IEEE 802.3ay (IEEE P802.3) D1.2 Maintenance #9 (Revision) comments

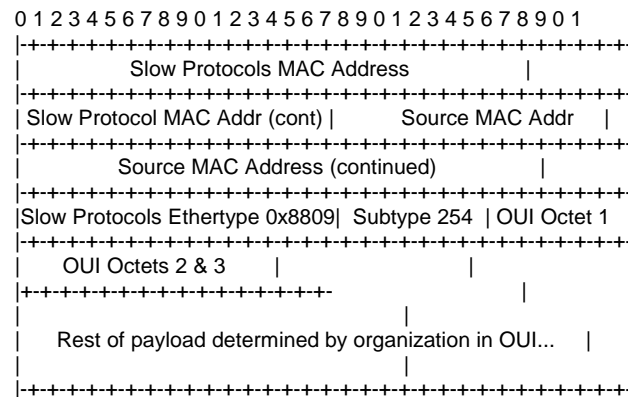
It was indicated in a liaison to ITU-T in July 2007 that we would add an OUI extension to the slow protocol definition in annex 57A during sponsor ballot. I have made this comment during WG ballot in case it may be possible to add the change before sponsor ballot.

Update Table 57A-3 to indicate the allocation of subtype 254 (0xFE) is "Reserved for Organization Specific Extensions, distinguished by Organizationally Unique Identifier."

Add a new subsection 57A.5 after 57A.4 (similar in style to 57.4.3.6)

The optional Organization Specific slow protocol, identified with the subtype field set to 0xFE, is used for organization specific extensions. The Organization Specific slow protocol PDU frame structure shall be as depicted in Figure 57–xx.

See comment #88.
